**SUSITNA
HYDROELECTRIC PROJECT**

FEDERAL ENERGY REGULATORY COMMISSION
PROJECT No. 7114

**ALASKA POWER AUTHORITY
COMMENTS
ON THE
FEDERAL ENERGY REGULATORY COMMISSION
DRAFT ENVIRONMENTAL IMPACT STATEMENT
OF MAY 1984**

**VOLUME 2B
TECHNICAL COMMENTS
-AQUATIC RESOURCES**

ALASKA POWER AUTHORITY		
SUSITNA PROJECT		
SUSITNA RIVER PROGRESSION OF ICE FRONT & ZERO DEGREE ISOTHERM		
WARZA-EBASCO JOINT VENTURE		
DATE: 01.04.88	BY: J.M. 88	1000.142

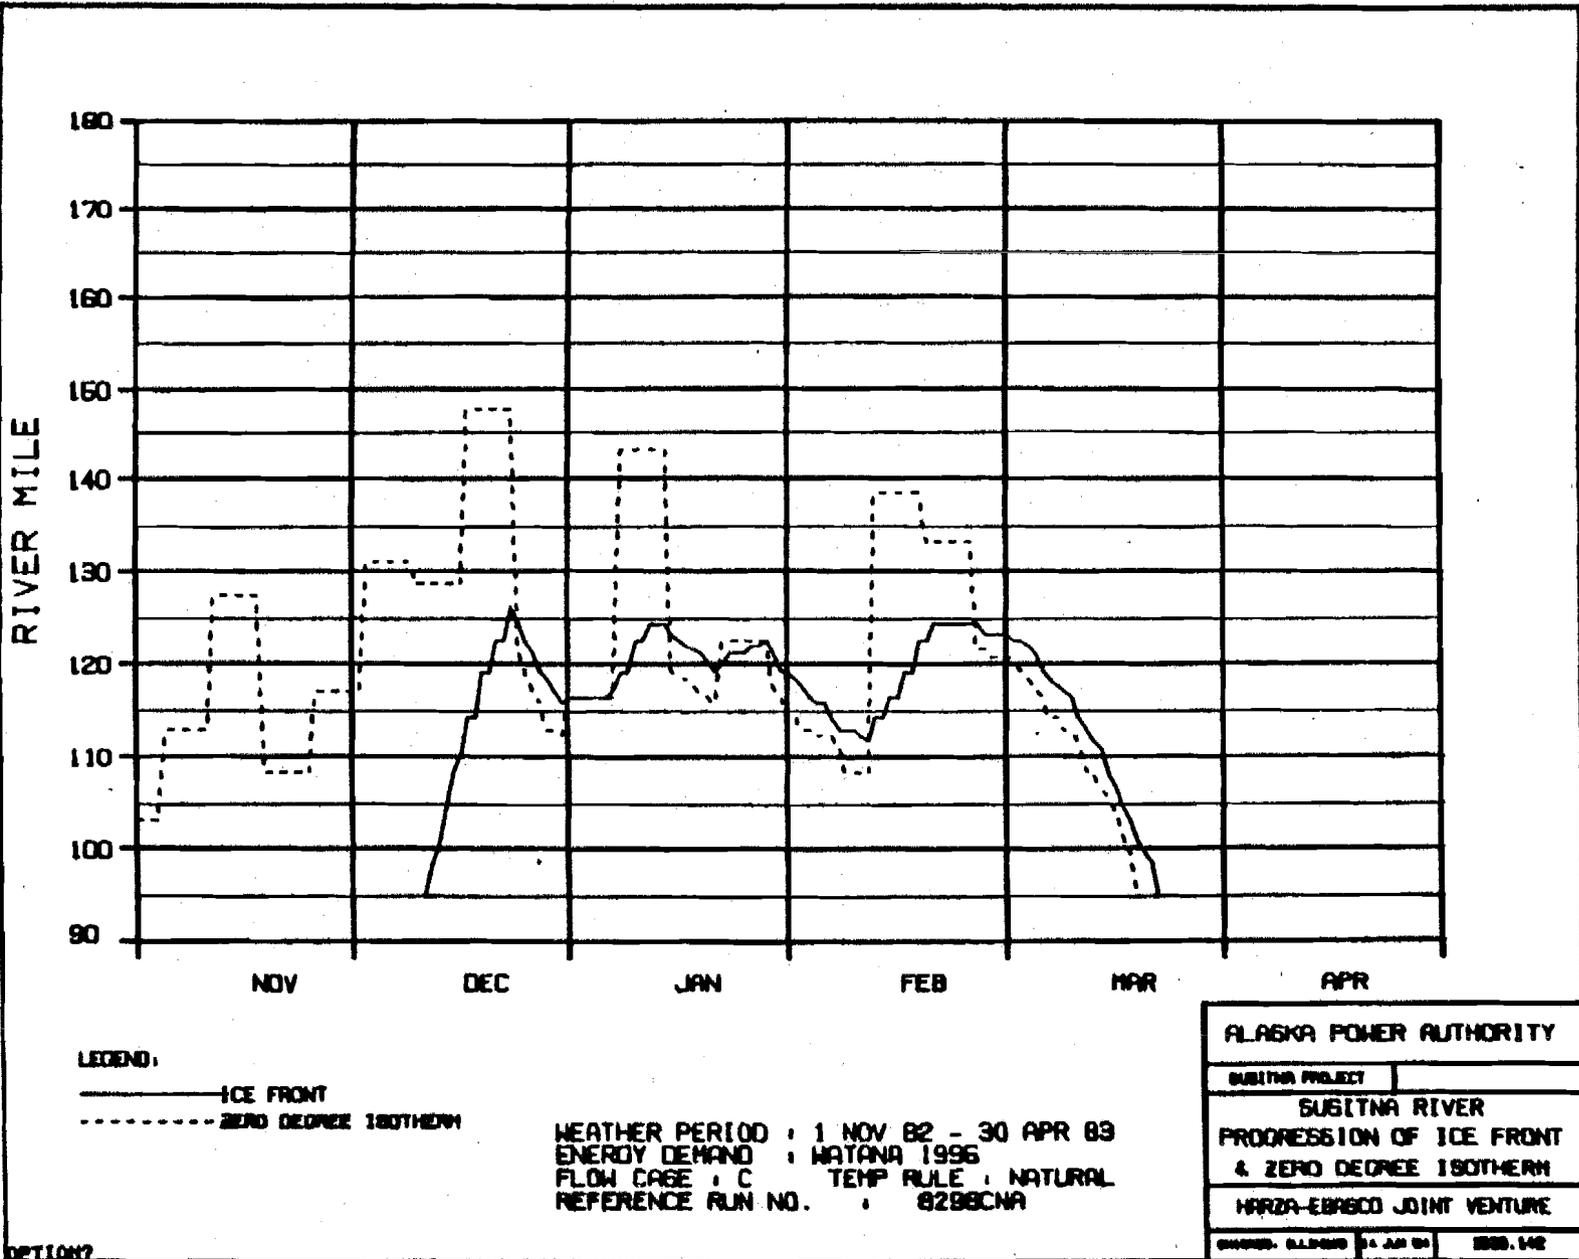
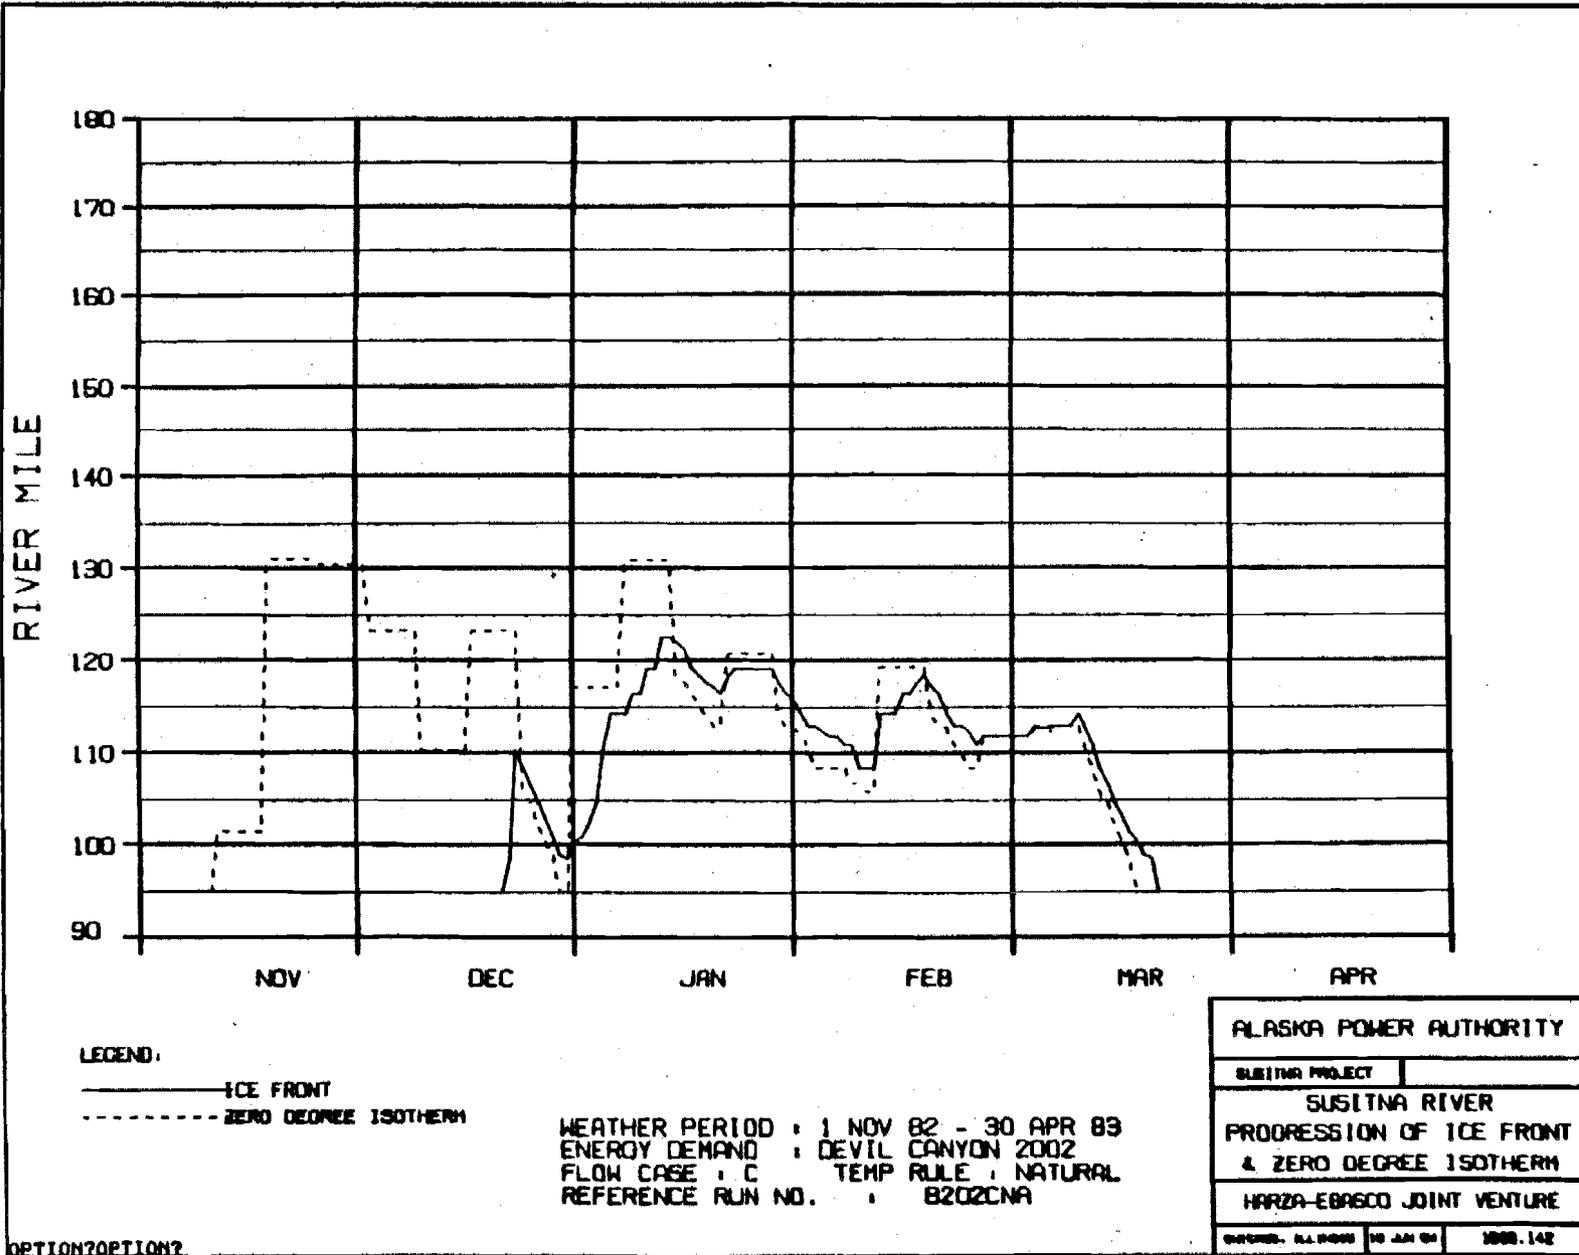
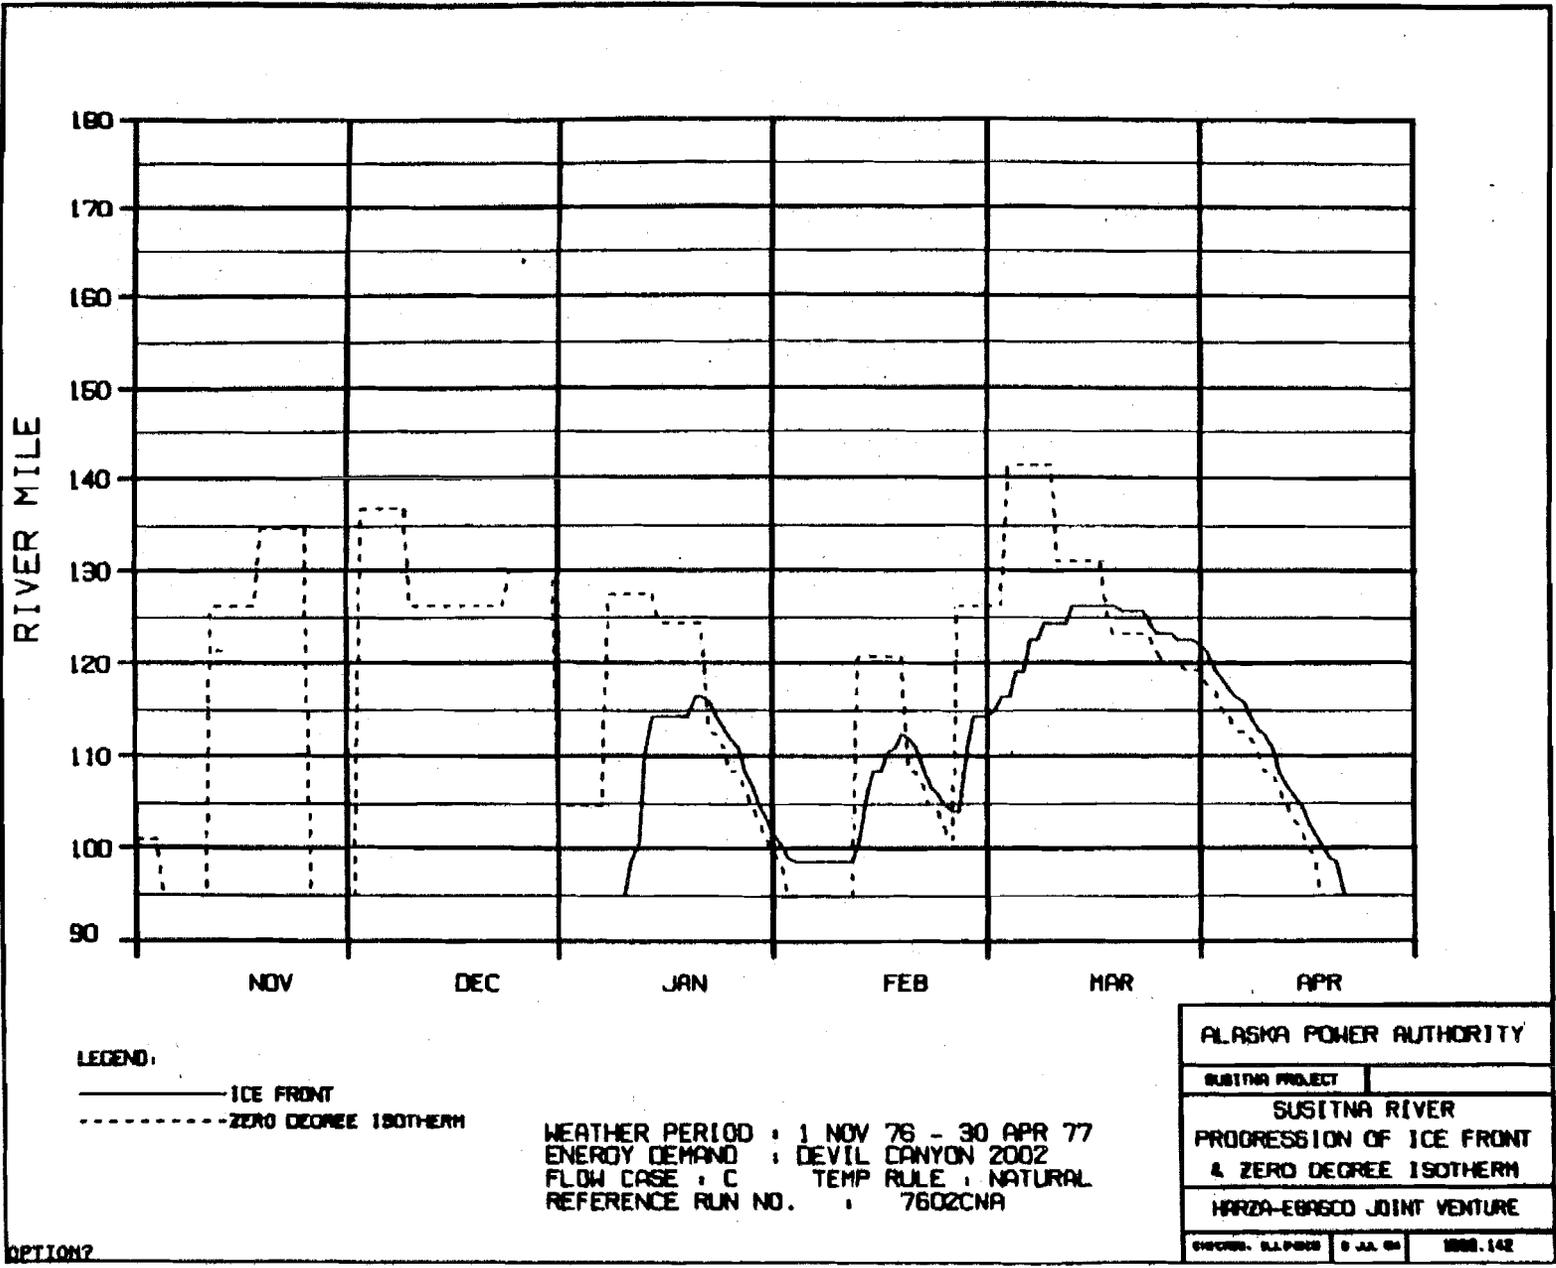
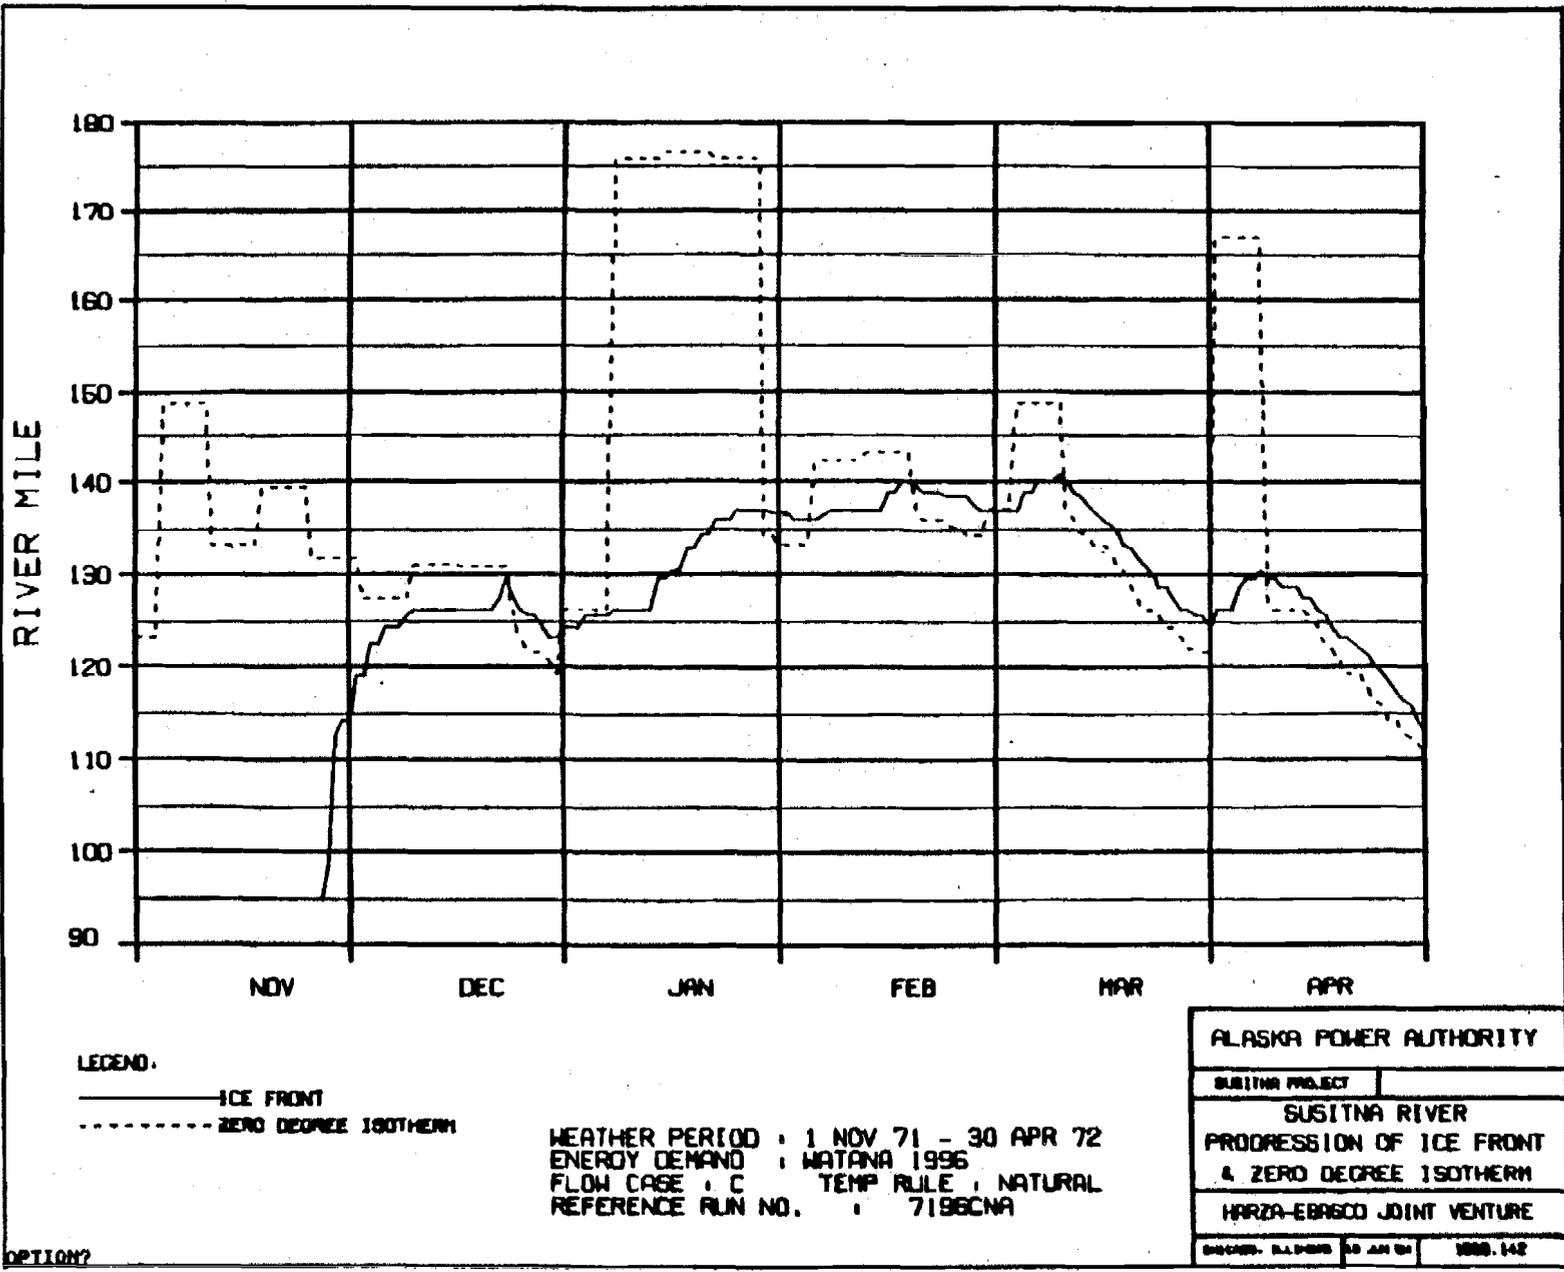
the observed beginning for progression up the middle reach was around November 2 (Exhibit A). With Watana only, the progression is expected to begin on December 10 (Exhibit B).

Higher winter flows with-project are expected to result in generally thinner ice, but slightly higher water levels (with less staging) than preproject. The most significant difference is the zone of open-water downstream of Watana with-project. For instance, simulations using the 1982-83 winter climate data indicate that the open-water zone would extend approximately 60 miles downstream of Watana (Exhibit B). Even with the higher winter power demand in year 2001, and with the addition of Devil Canyon operation in 2002, the ice front is expected to advance only approximately 25 miles upstream of the Chulitna confluence. (Exhibits C, D, and R).

Using the 1976-77 winter hydrological and meteorological data, with average air temperatures similar to 1982-83 for simulated natural conditions the ice front would reach Gold Creek (River Mile 136.6) in late February (Exhibit B). With Watana only operating the ice front would reach Gold Creek in late March (Exhibit E). With Watana and Devil Canyon operating the ice front would advance only approximately 25 miles upstream of the Chulitna confluence (Exhibit F).

In cold winters such as 1981-1982, under natural conditions the ice front would be expected to reach Gold Creek in early January (Exhibit Q). With Watana only operating the ice front would advance to Gold Creek in late January (Exhibit G). With Devil Canyon operating the ice front would only advance to near River Mile 125, downstream of Slough 8A (Exhibit J).

The with-project meltout will generally take place over a longer time period than pre-project breakup. Exhibits A-R show meltout occurring in 2-4 weeks, whereas pre-project breakup generally occurs in 1-2 weeks.
